# Wisconsin Department of Transportation

**Proposal #18: 2120-16-70, WISC 2019 289**  
**STH 24**  
**Intersection with 92<sup>nd</sup> St**  
**STH 24**  
**Milwaukee County**

This is Addendum No. 01, which provides for the following:

**ADDENDUM NO. 02**

Addendum No. 01  
ID 2120-16-70  
Revised Sheet 31  
May 2, 2019

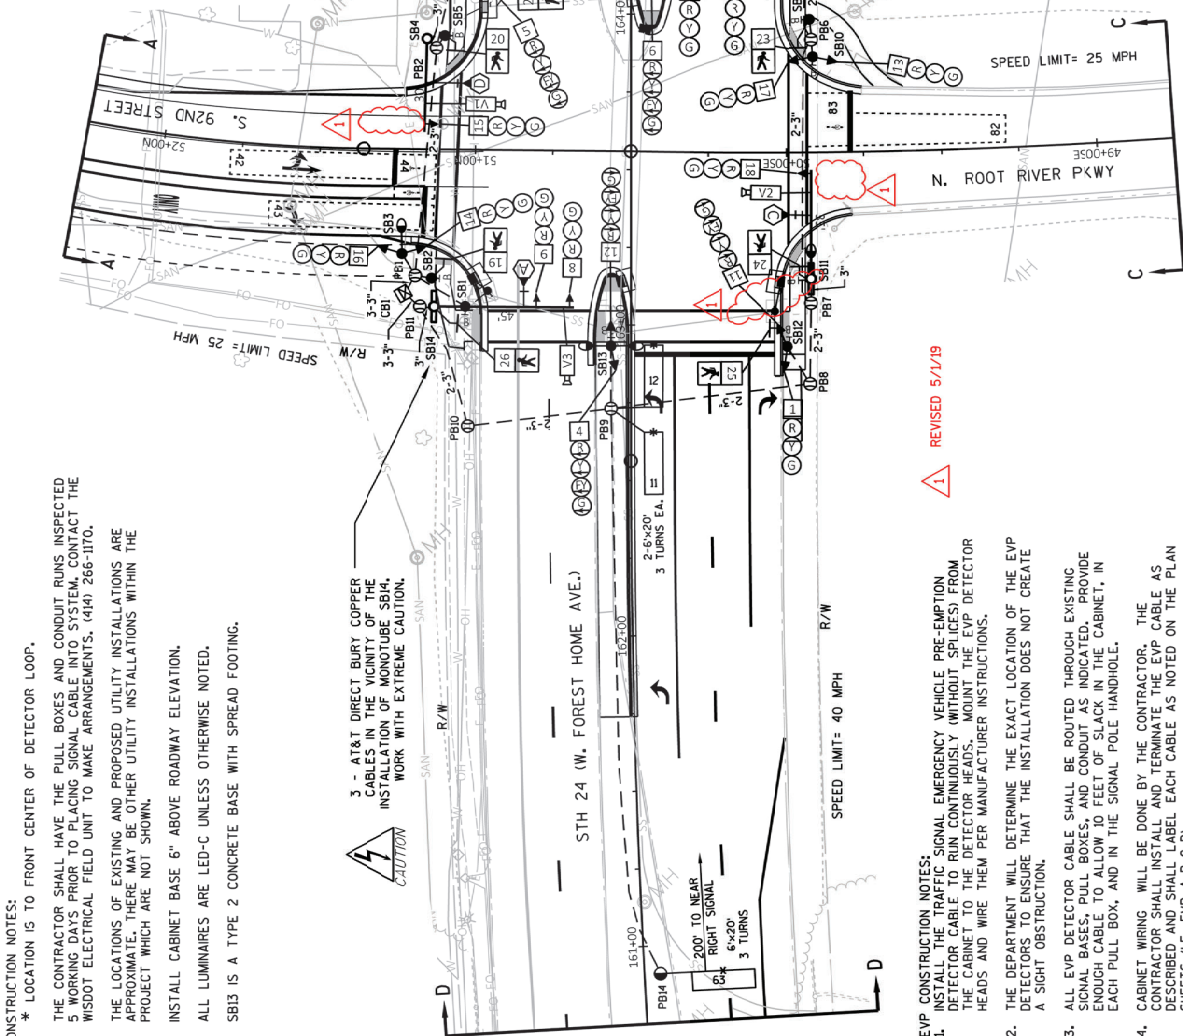
<b>Revised Plan Sheets</b>	
Plan Sheet	Plan Sheet Title (brief description of changes to sheet)
31	Traffic Signal Plan – changed callout
35	Revised Video Detection Cable callout
73	Change callout on cameras
77	Miscellaneous Quantities – Added State Furnished items, removed SPV0.0060.04
